| <b>DATE:</b>         | 11/10/2023                                            |
| <b>PROJECT/JOB#:</b> | 222006 Milford Medium Voltage Loop Completion - Rebid |
| <b>ADDENDUM #:</b>   | 3                                                     |

ELECTRICAL SITE PLAN

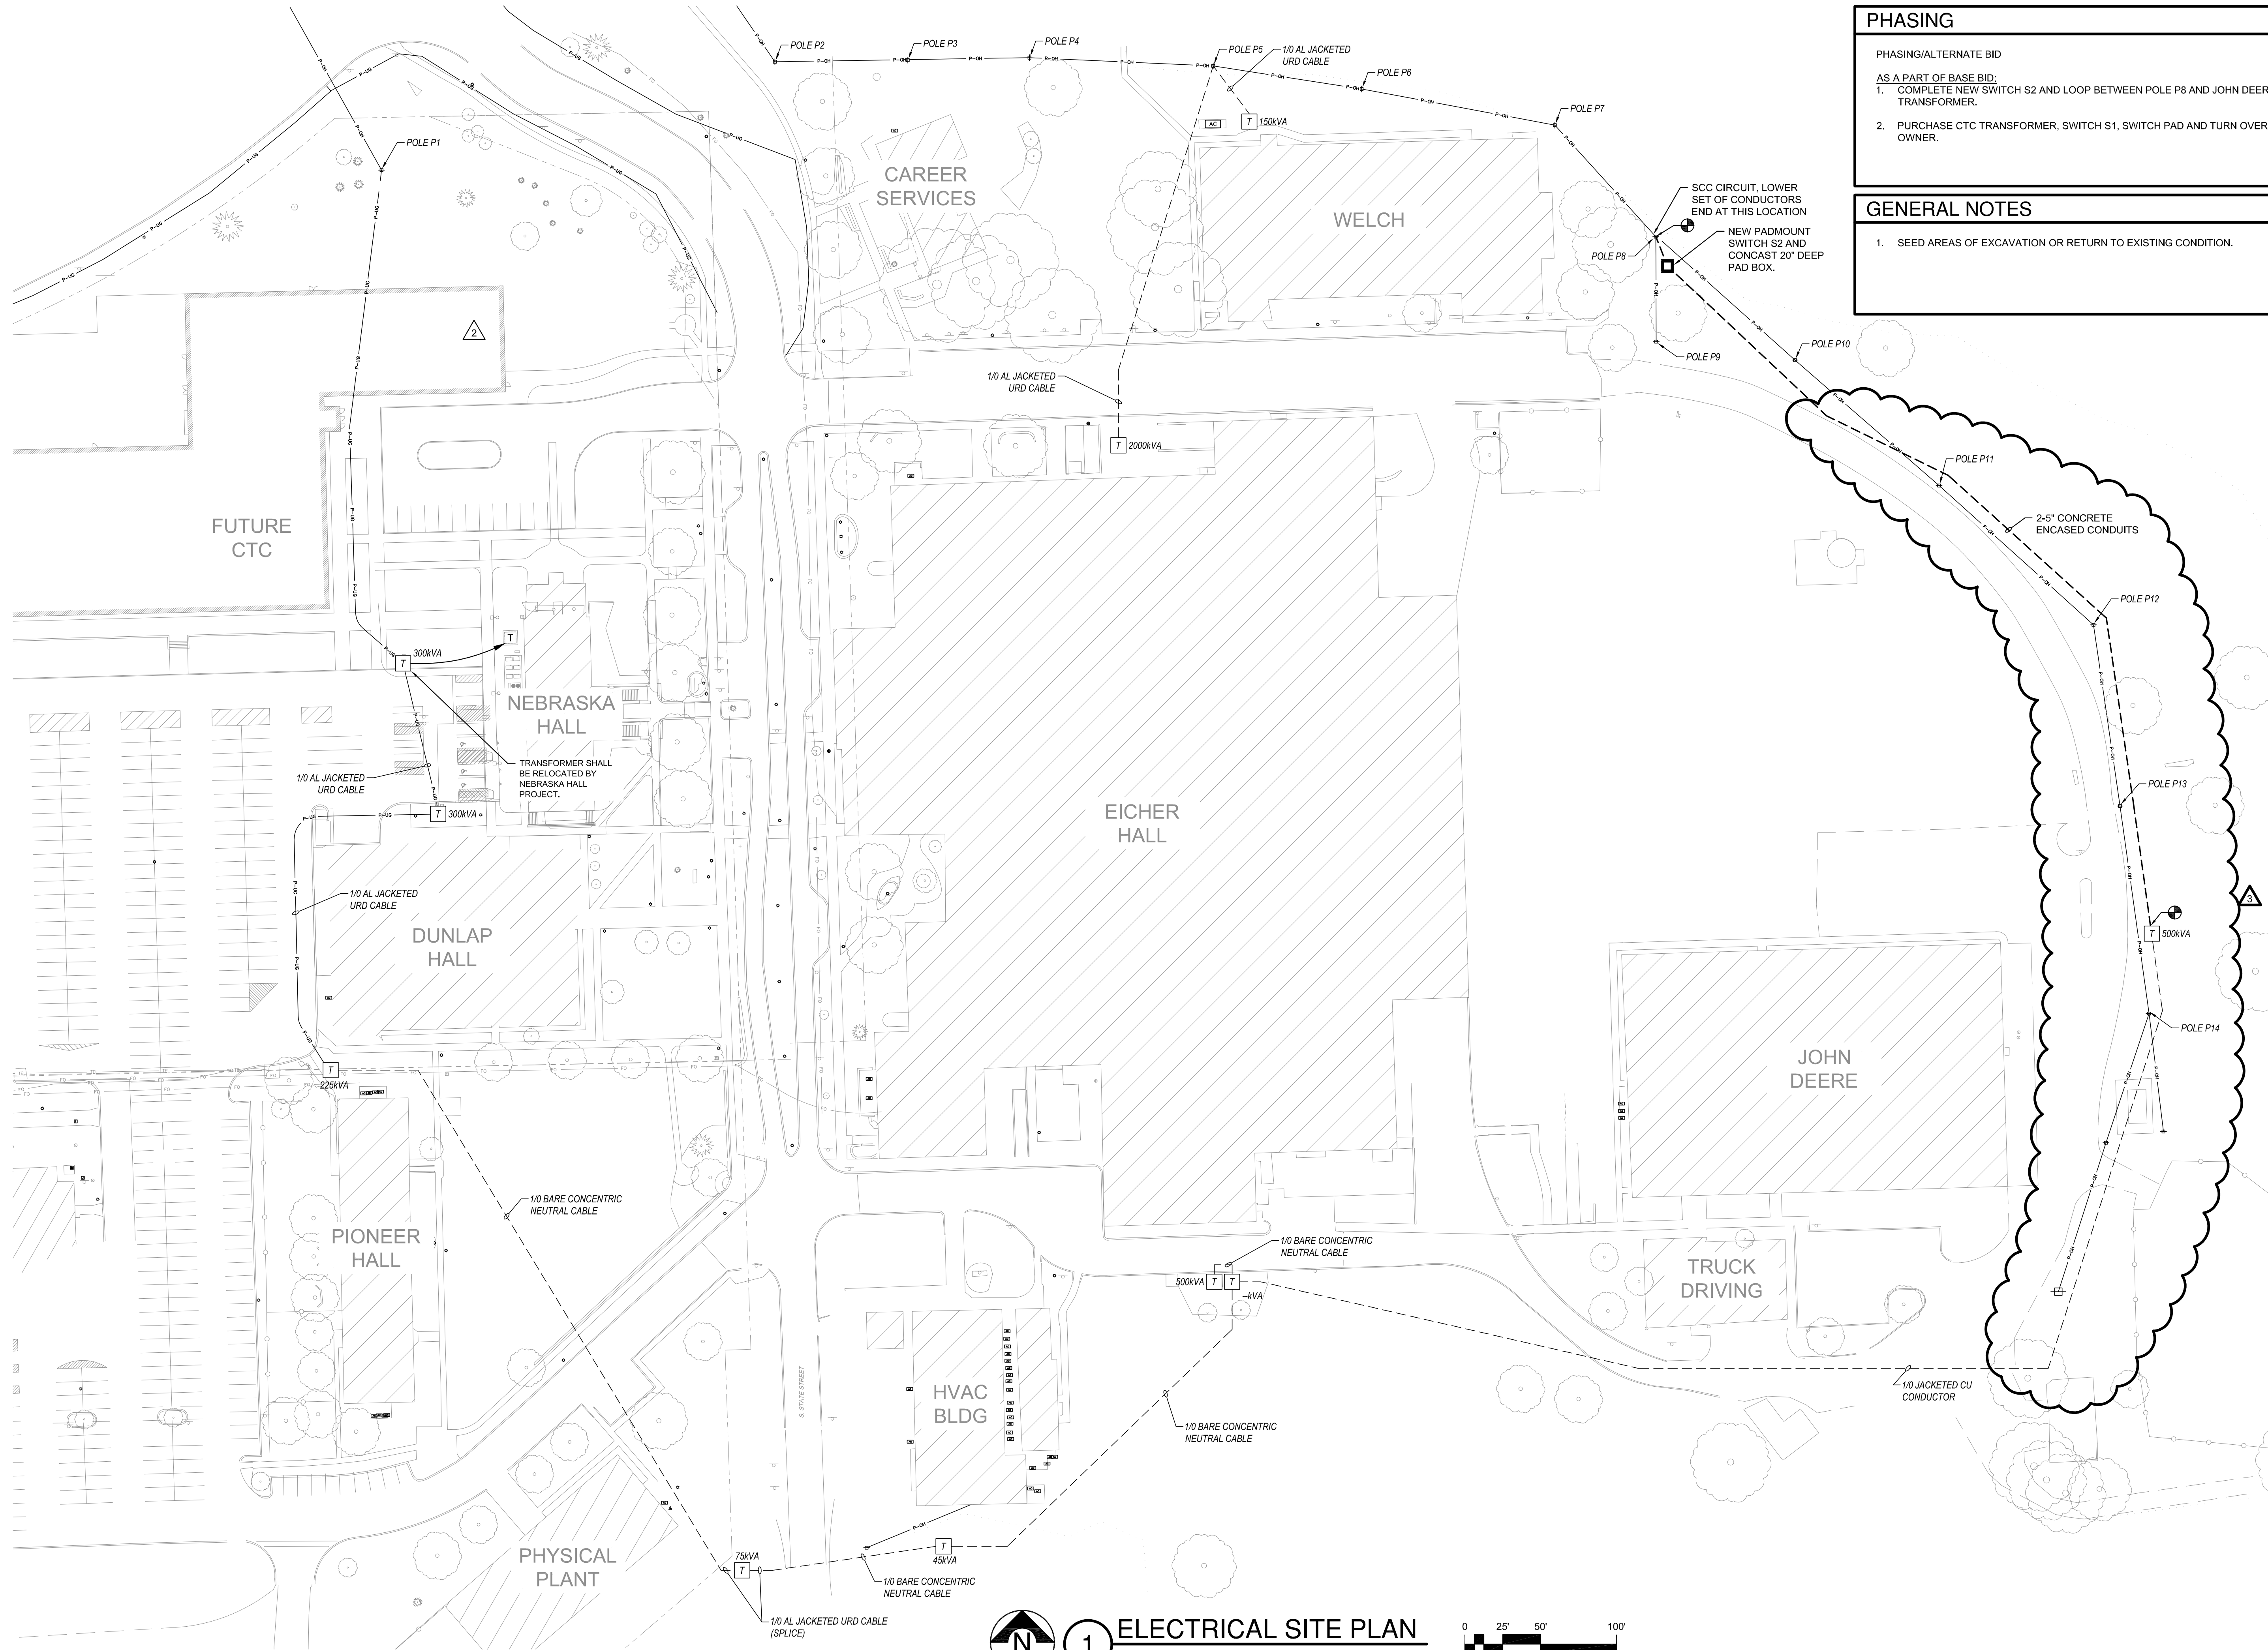
1. Question: The addendum talks about the west side but not the east side, will we bore under the pavement, or will the concrete be removed? Will the transformer be in the green space or in the pavement. I'm assuming they will want bollards around the transformer. If so, how many? Size?
  - a. Answer: The existing 500KVA transformer at John Deere is located east of the existing pavement. The duct bank can be routed east of the pavement without crossing. Provide concrete encased ductbank as specified between Switch S2 and existing transformer. Transformer location modified in this addendum.
2. Question: What are the intensions of the equipment we furnish under this contract but install later under a separate contract? Under this bid we are furnishing both Switch S1 and S2, but only installing S2/PME-5?

5. Question: The new ductbank going in on the east still requires crossing a paved road. Are we to remove part of the paving or bore under and not concrete encase?

- a. Answer: The existing 500KVA transformer at John Deere is located east of the existing pavement. The duct bank can be routed east of the pavement without crossing. Provide concrete encased ductbank as specified between Switch S2 and existing transformer. Transformer location modified in this addendum.

### 3 DUCTBANK DETAIL

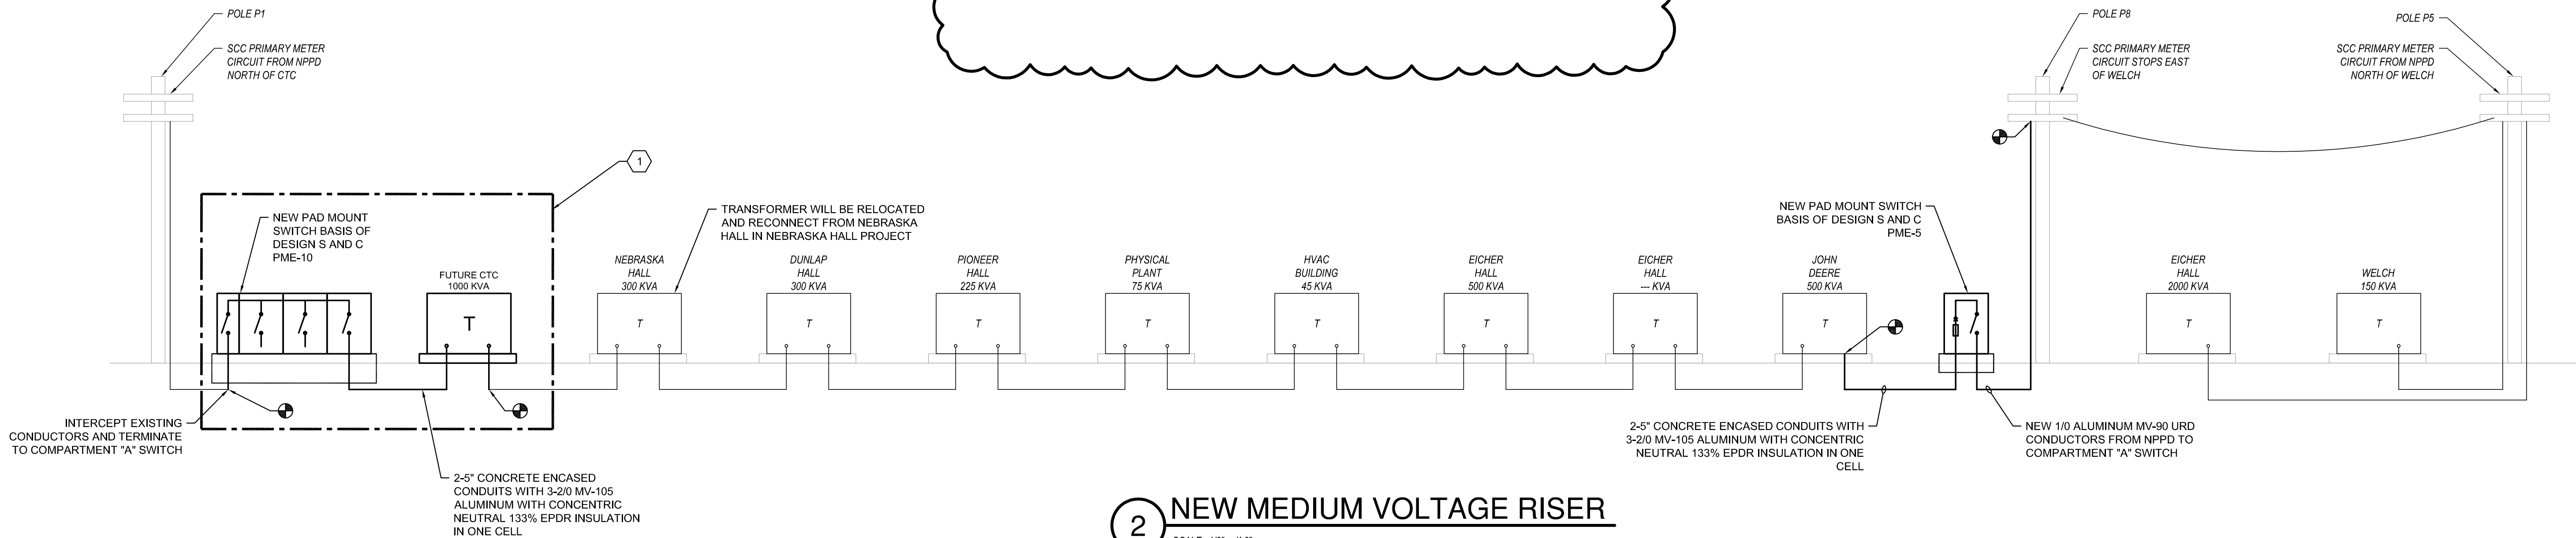
6. Question: The one-line indicates (2) 5" conduits, but the detail says (4). Please clarify that we are only furnishing (2) 5" conduits.
  - a. Detail reissues in this addendum.
